Docket Item #s 8 & 9
BAR CASE # 2009-0016 &
BAR CASE # 2009-0017

BAR Meeting
April 1, 2009

ISSUE: Addition and alterations and Waiver of HVAC Screening Requirement

LOCATION: 117 South Lee Street

Figure 10. Proposed addition elevations: side (south), rear (west), and extended portion (east).

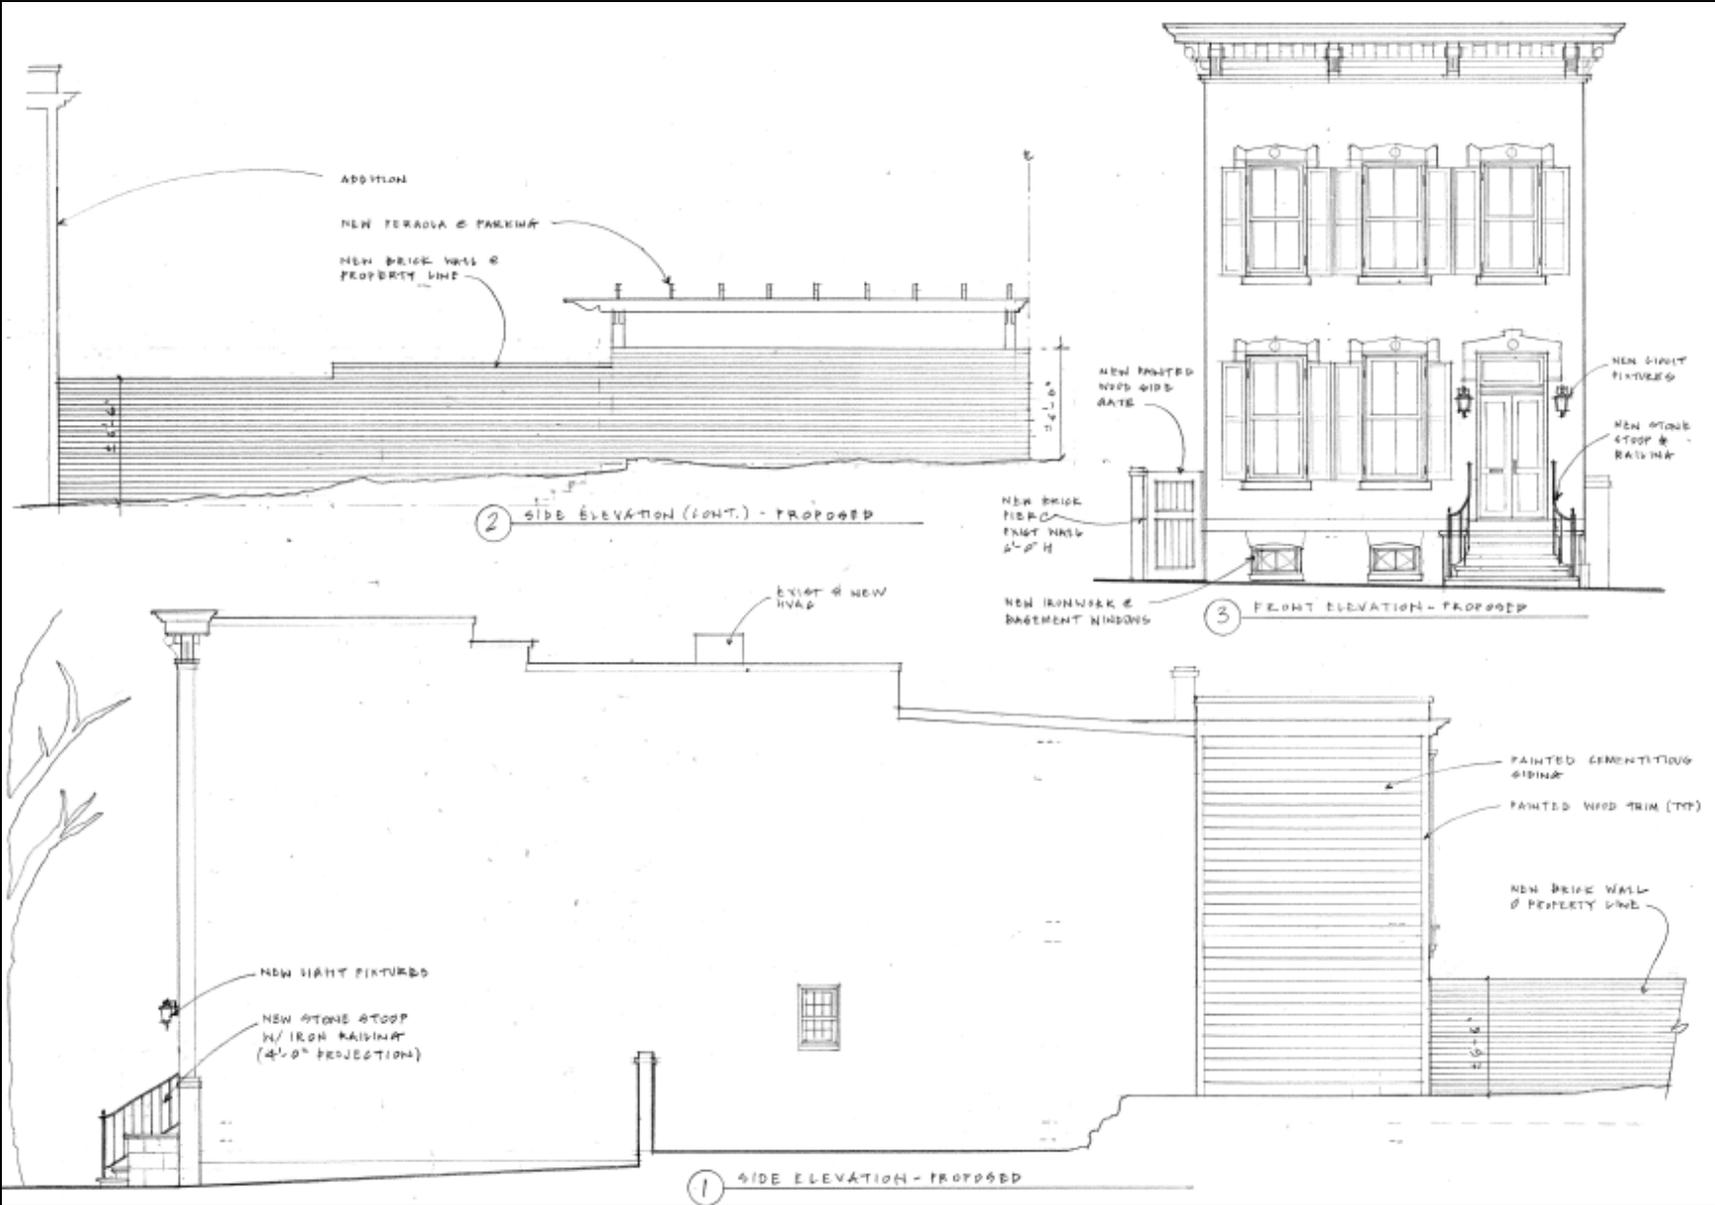
Upon receipt of the original submission, Staff expressed concerns to the applicant regarding the height and massing of the proposed addition. While the applicant has since lowered the height of the parapet by approximately 6 inches, Staff continues to find that the addition should be further reduced. Specifically, Staff finds that an addition should be no wider than the existing historic house (14.7 feet at the rear ell and 20 feet at the main block). While appropriate, and even encouraged, to differentiate new construction from historic fabric, Staff finds that the extension of the addition beyond the historic building’s wall plane is generally not an appropriate treatment. A more common form of differentiation would be offsetting the addition to have it step in from the historic house. However, the addition is appropriately differentiated from the historic house through the change of materials and shift in architectural vocabulary. Generally, additions should be subordinate to a historic building, specifically in regard to height. As proposed, the addition is still approximately 2 feet higher than the rear of the house. Staff recommends that the applicant continue to reduce the height and massing of the proposed addition in a way that maintains the proportions of the classical revival architectural design. Staff recommends that the north elevation of the proposed addition be stepped in so that it is either flush with or slightly inset from the plane of the existing north elevation, and that the addition be reduced proportionately to this reduction to retain the proposed classical proportions. Although the roof will still be slightly higher than the rear ell with this reduction, Staff finds that

the reduction must be done proportionately to not impact the design. Further, Staff estimates that the difference in roof height will be negligible once this change is made.

1. That the addition be stepped in on the north elevation so it is either flush or slightly inset with the plane of the existing north elevation, and that the addition be reduced proportionately to this reduction to retain the classical proportions and design of the proposed addition.

Figure 11. Proposed elevations: front (east) and side (north).

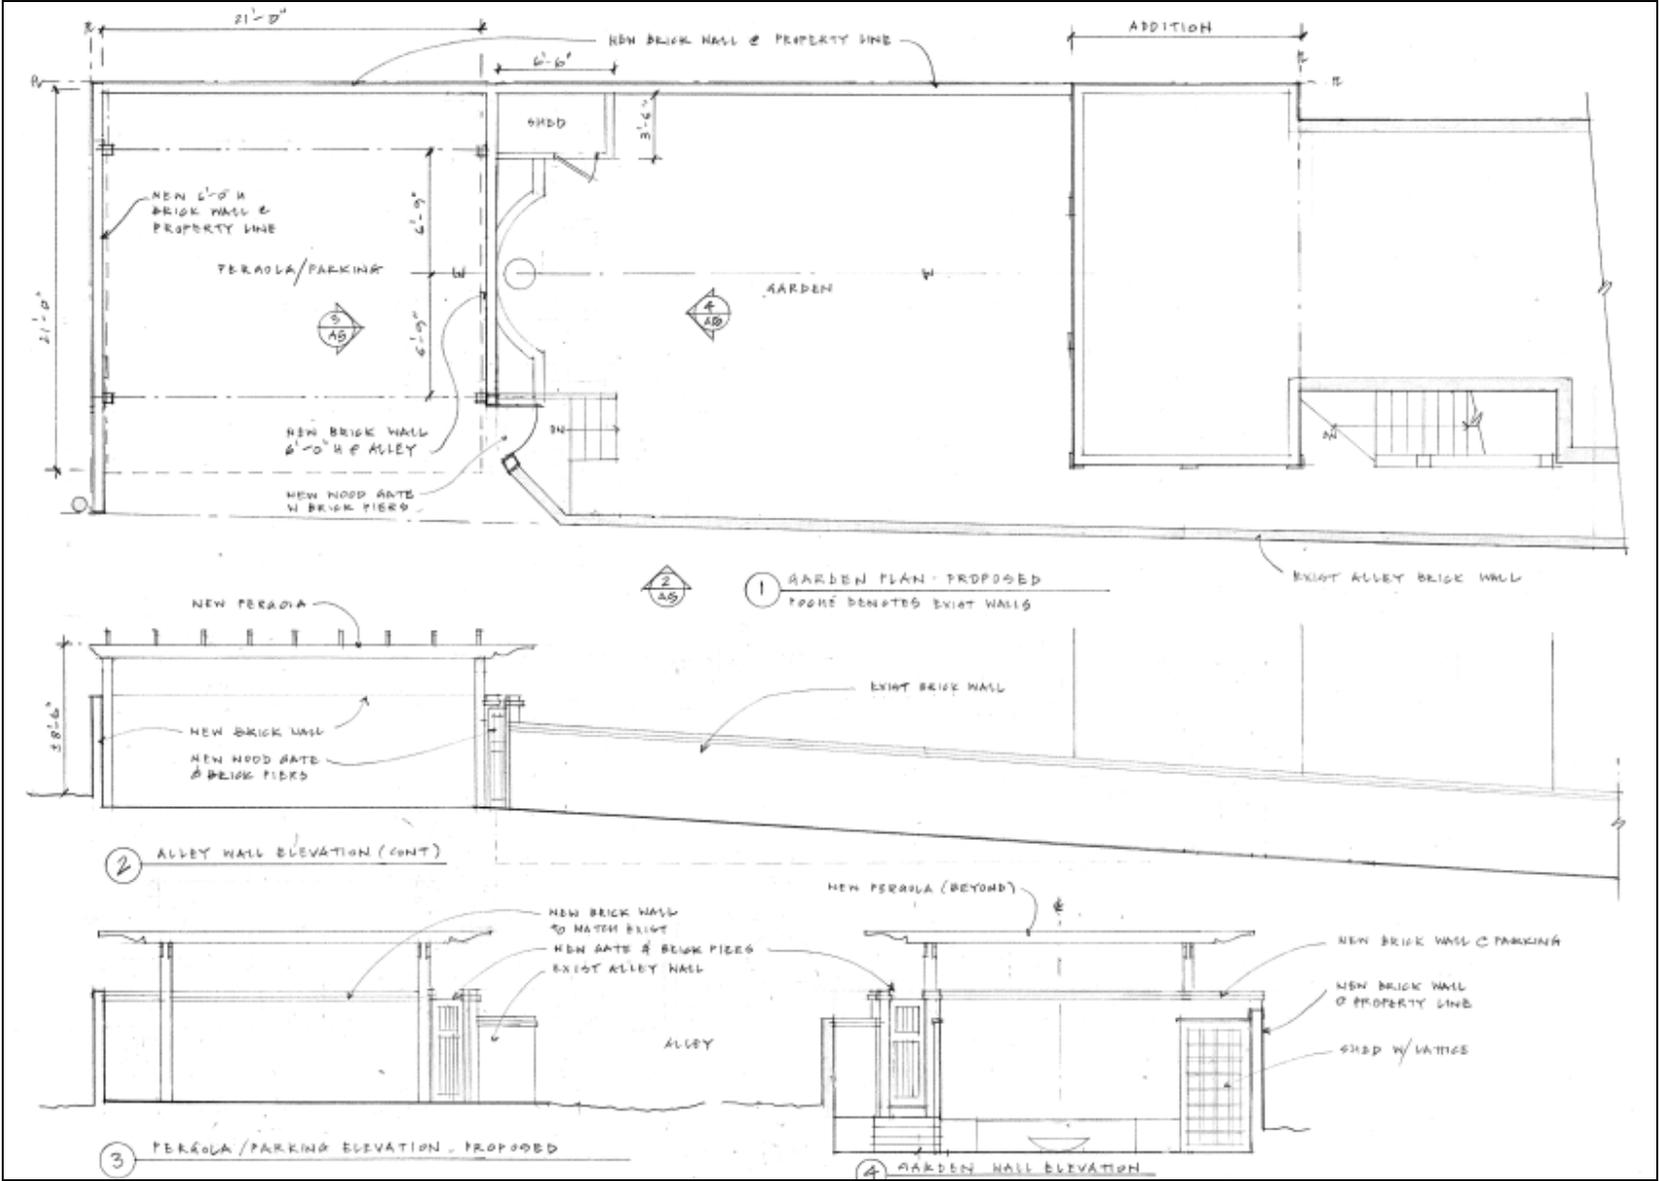
The existing side-loading front stoop, made of brick and concrete, does not appear to be historic. The proposed limestone stoop is consistent with the *Design Guidelines* which state that “stoops, steps and railings should be made of materials which are sympathetic to the building materials generally found in the historic districts” and “should be appropriate and compatible with the historic architecture of the building.” Staff continues to find that the proposed limestone stoop is compatible.

Figure 13. Proposed alterations to rear yard area including garden walls, pergola and shed.

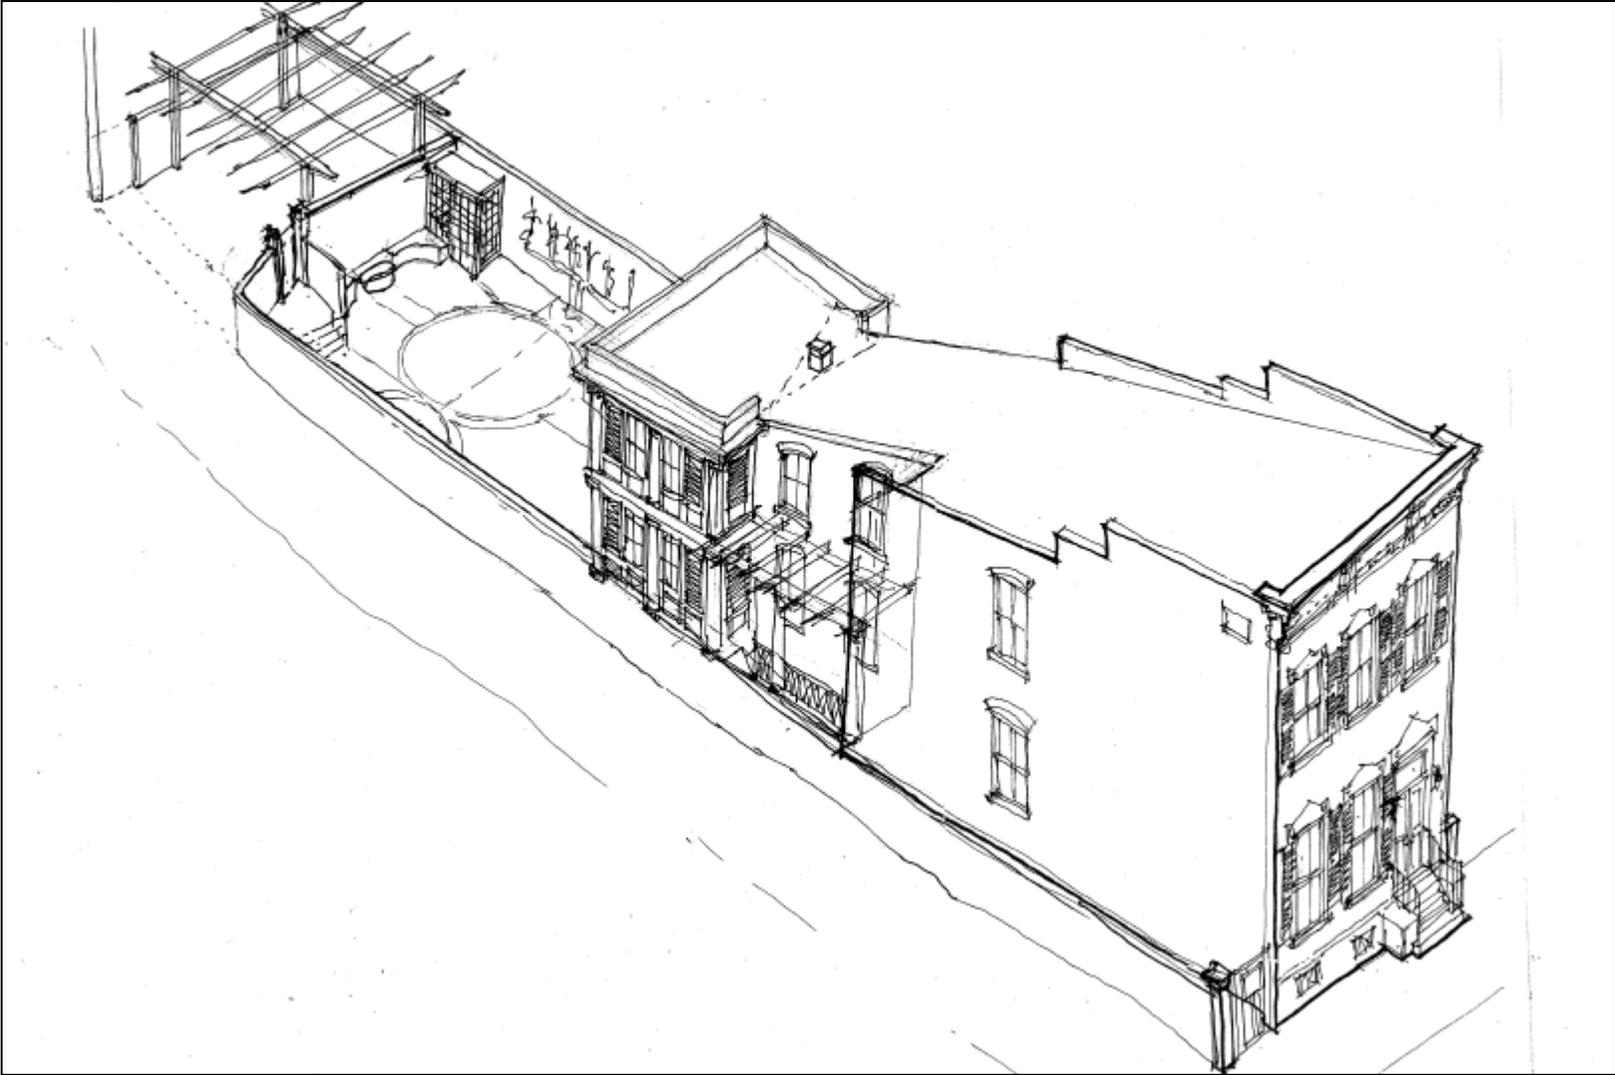
The *Design Guidelines* pronounce that “an important visual feature of the historic districts are the fences, garden walls and gates that define property lines...[and] serve as a distinctive feature of the streetscape and individual yards.” Originally, the applicant proposed demolition and alterations to the historic garden wall on the alley (south) property line, which was of great concern to Staff. The applicant has since revised the application to leave the historic garden wall untouched. Staff finds that the construction of new brick piers, adjacent to the historic garden wall are appropriate and will ensure that the historic garden wall will be retained as both a useful and historic element. Staff finds that the new brick garden wall on the north and west property lines is acceptable as it has been revised to be no higher than 6-6.5 feet in height above grade at the property line and is stepped to accommodate grade changes without added height. This contrasts with the original submission which proposed a height of 8.5 feet on the north property line.

Staff finds the proposed pergola over the parking area to be appropriate in design, scale and materials. The proposed alterations to the garden area, including the shed, are appropriate. Due to the reduction in grade in the rear yard, the shed will be minimally visible. The proposed painted wood gates are appropriate.
